City of Plymouth Planning Commission

Regular Meeting Agenda

- a. **SP26-03:** Special land use request for indoor recreation uses at 350 S. Mill. The property is zoned I-2, Heavy Industrial.
- b. **PUD26-01:** Preliminary PUD request for multi-family use at 639 S. Mill and 188 E. Ann Arbor Trail. The properties are zoned Expired PUD.

SUBJECT: SPECIAL LAND USE PERMIT APPLICATION COMMENT RESPONSES

Date:	10/14/25
Scale:	1"=20'
Sheet:	C-501
Project:	20713.00

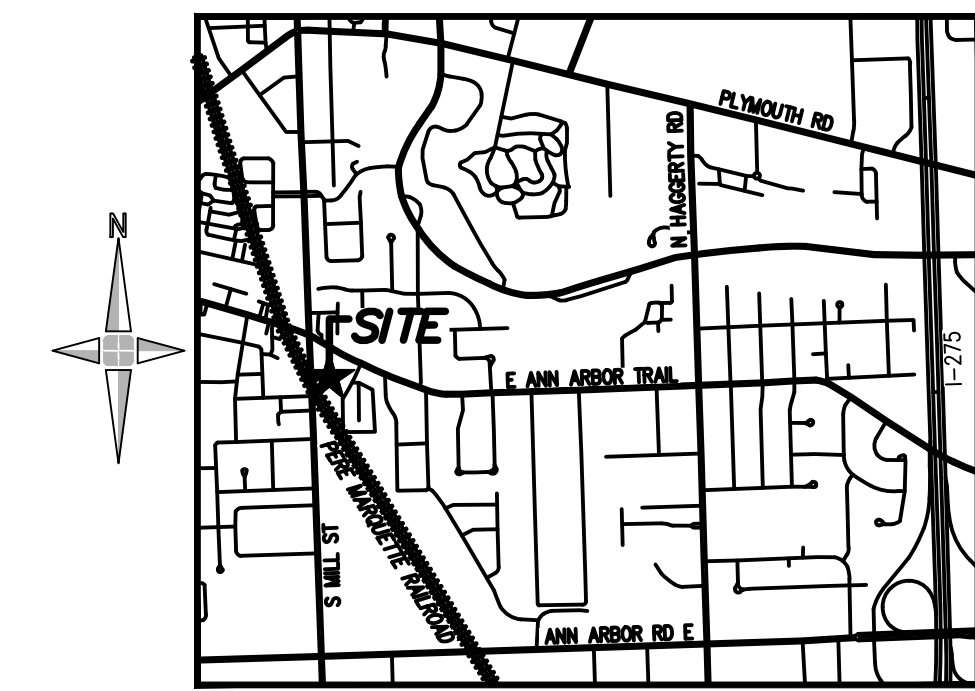
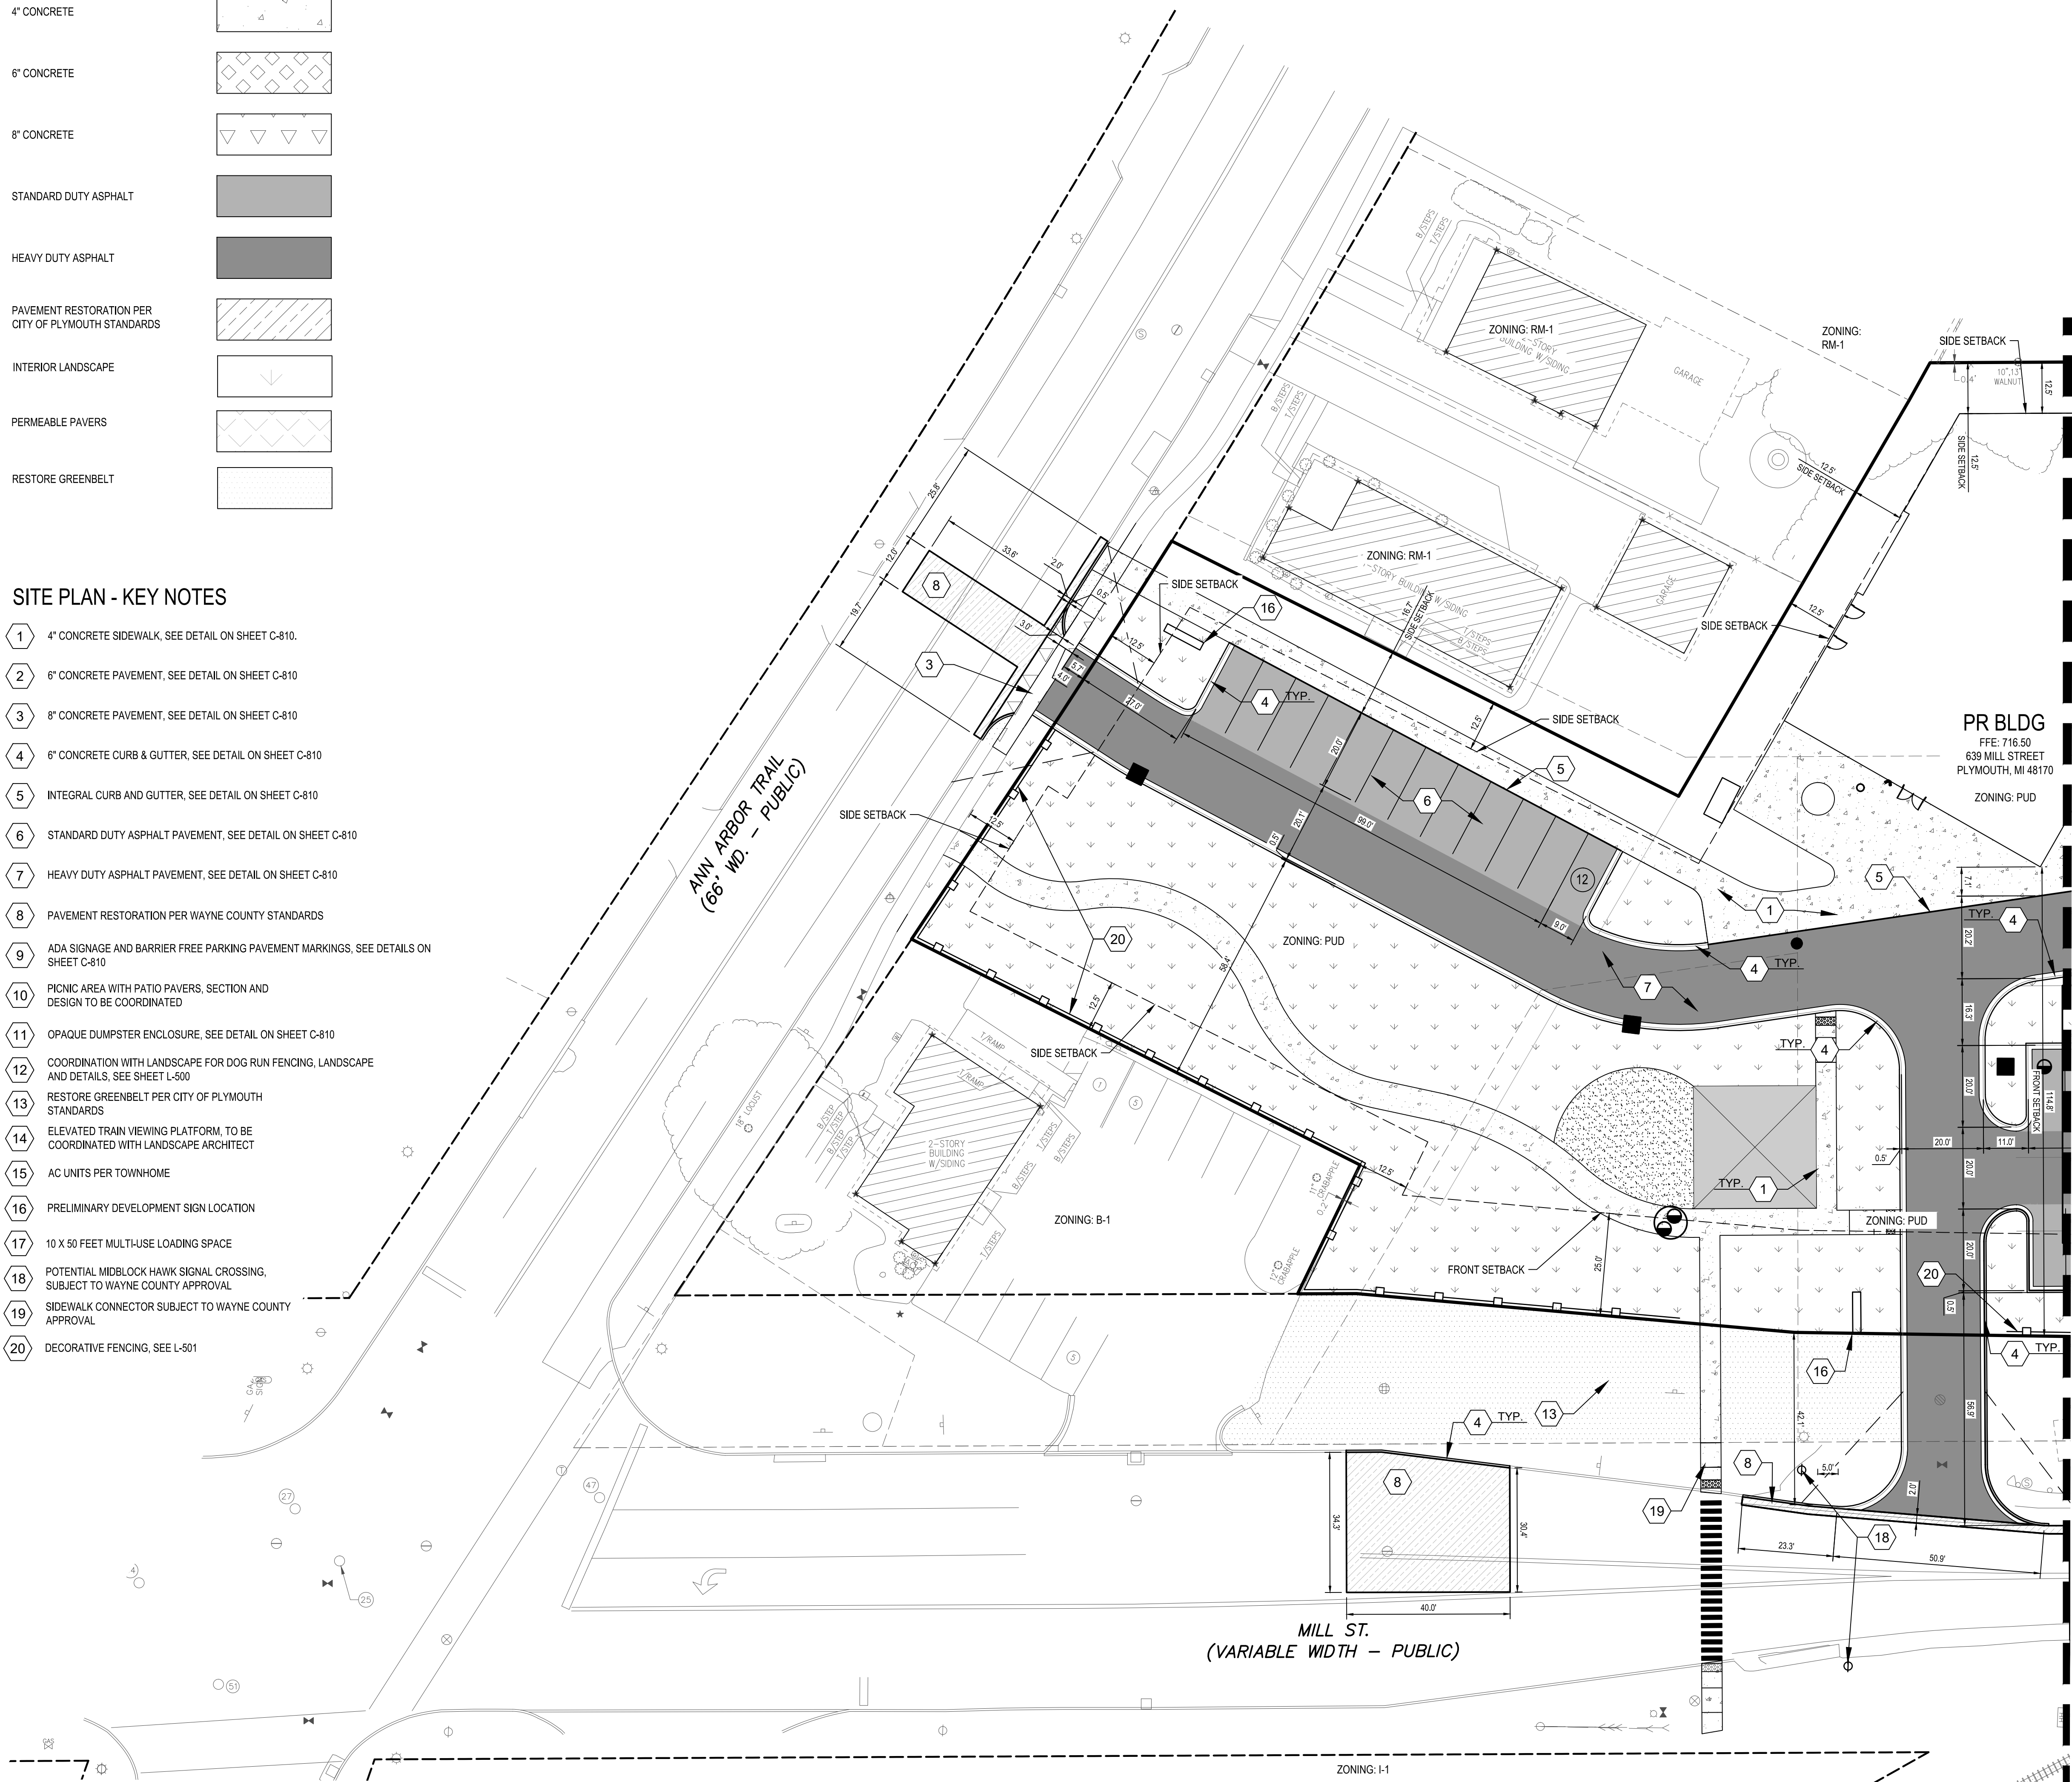
6. **Improved pedestrian connectivity and safety.** *CWA Comment: The plans (Sheet C-501) have been amended to remove the proposed sidewalk along Mill St. from the intersection of Mill St. and Ann Arbor Trail south to the sidewalk entrance to the project. However, the proposed park has a sidewalk that would allow a pedestrian to walk between Ann Arbor Trail and the crosswalk over S. Mill St. Also shown on the revised plans is a mid-block crossing with rectangular rapid flashing beacons to assist pedestrians in crossing Mill St. on their way to and from downtown Plymouth. We consider the crosswalk with beacons to be a "public benefit." On the most recent plan set, the location of the crossing has been adjusted to avoid the existing guardrail on the west side of Mill St. This location allows pedestrians using the new crosswalk to get to the sidewalk on the west side of S. Mill St.*

- Label the park on the plans as "public" to meet the PUD criterion for a "public benefit."
- On Sheets C-501 and C-502:
 - Label the setback along S. Mill St. as a "front," and locate the setback line 35-feet from the front property line.
 - Label the setback along the east side of the project as a "rear," and locate the setback line 35-feet from the rear property line.

Date:	10/14/25
Scale:	1"=40'
Sheet:	C-700
Project:	20713.00

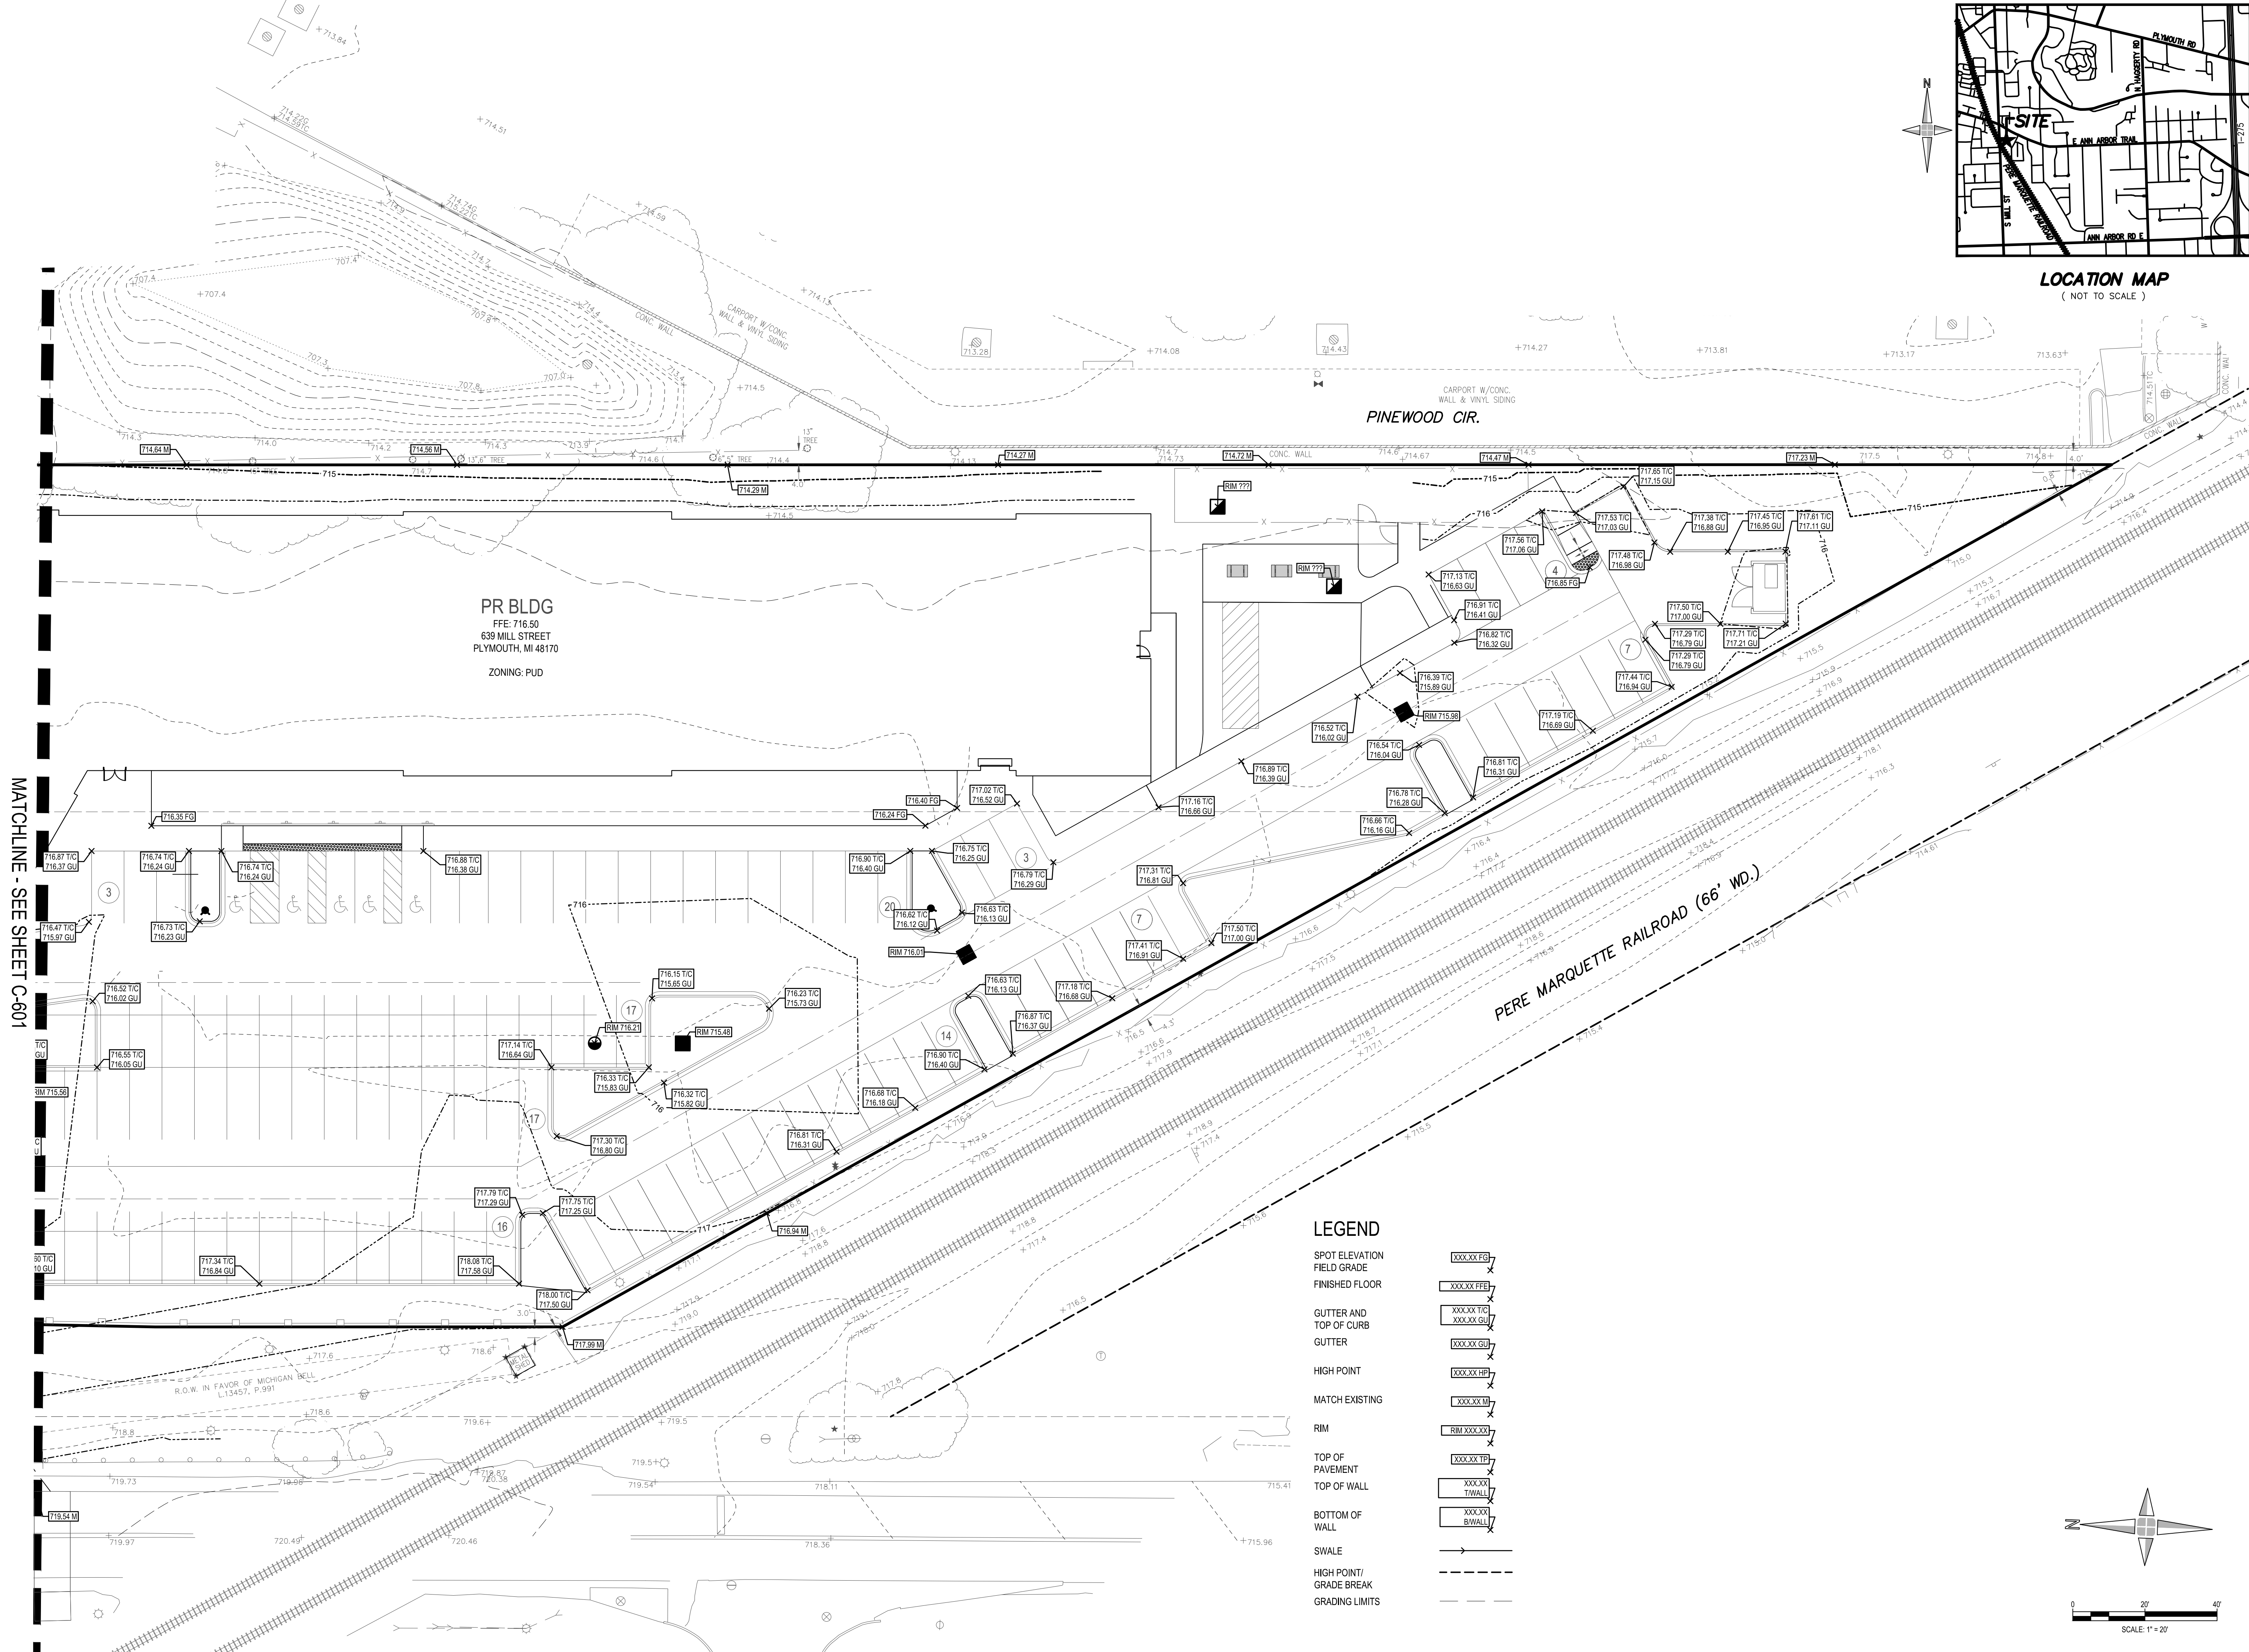
- C. Utility Plan Sheet C-700 proposes new water main as part of the project. The proposed size and material for the new water main does not appear to be shown on the plans. A minimum size of eight-inch will be required and an Act 399 permit from the State of Michigan Department of Environment, Great Lakes, and Energy (EGLE) will be required for all new water main. Following final engineering approval, the Developer will be required to provide sufficient information to assist the City with the required permit application.

- B. Utility plan sheet C-700 and C-701 include a proposed sanitary sewer coming from the proposed building and connecting to an existing sanitary manhole in the Mill Street right of way. The size of the proposed sanitary sewer/lead is not currently shown.

- A. The existing water main on Ann Arbor Trail is shown on Utility Plan sheets C-700, C-701, and C-702. We believe that the existing water main on Ann Arbor Trail is six inches in size and likely cast-iron pipe. The existing water main size should be confirmed and added to all utility plan sheets.

- B. The existing water main on Mill Street is shown on Utility Plan sheets C-700, C-701, and C-702, however, we do not believe that it is shown correctly. The existing water main is 12-inch fusible PVC water main and was installed by the City (pipe bursting) along Mill Street in 2015. A copy of our record plan sheet can be provided to assist the applicant in drawing the location of the 12-inch existing water main on Mill Street.

- A. Stormwater Detention has been identified as part of this project, with limited details. Utility Plan Sheets C-700, C-701, and C-702 propose an on-site underground detention system in the parking area just south of the proposed driveway entrance off of Mill Street. The underground detention system is currently proposed for a 10-year rain event storage volume.

Figure 3. Screen Wall Locations and Landscape Strip Location

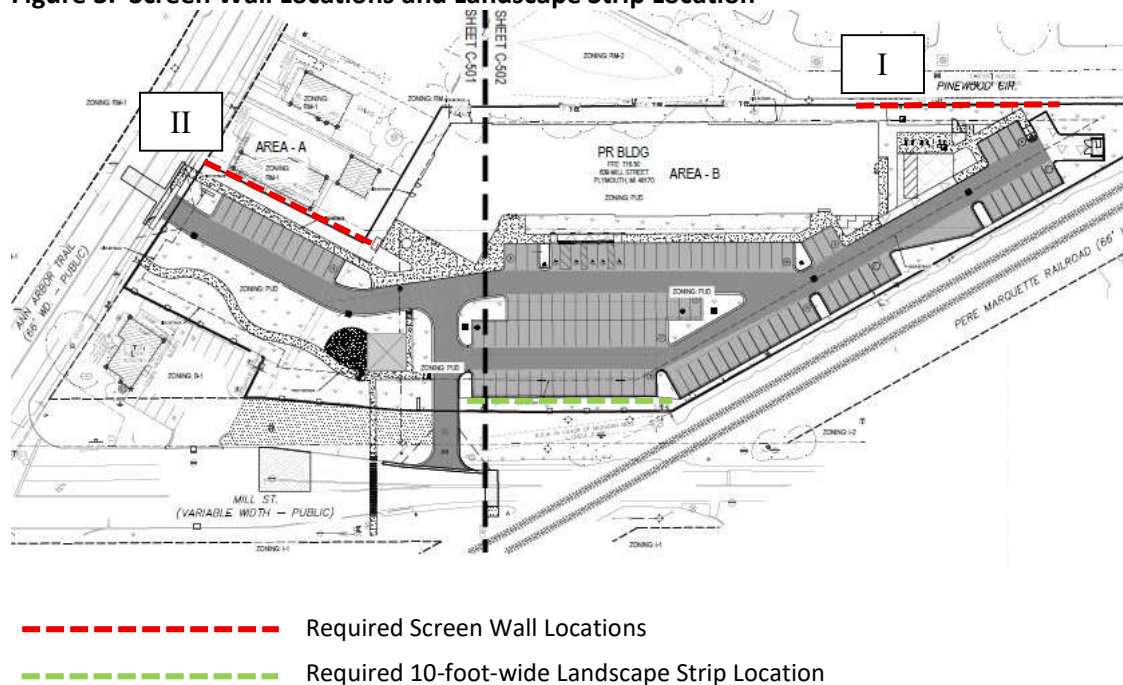
Sec. 78-272(6) requires an obscuring wall not less than 4.5-feet tall between off-street parking and an adjacent residentially zoned property. The illustration on the next page shows the property lines where this provision would apply. Paragraph (10) of this same section allows the Planning Commission to modify the wall requirement where unusual circumstances exist, and no good purpose would be served.

The comment about screen walls was in our previous review. The most current plans have not added any screen walls, although additional information has been provided below.

We have been informed that Pinewood Condominiums has a six-foot-tall masonry screen wall between the Lumber Mart site and their carports; therefore, no new wall is necessary. (Note that there is an inconsistency between the rendering of the Dog Park (Sheet G.004) and the Landscape Plan (Sheet L-202). The rendering shows trees along the east side of the Dog Park, but no trees are proposed in this location on the Landscape Plan. There are also no trees on the adjacent property (Pinewood Condominiums) next to the Dog Park.)
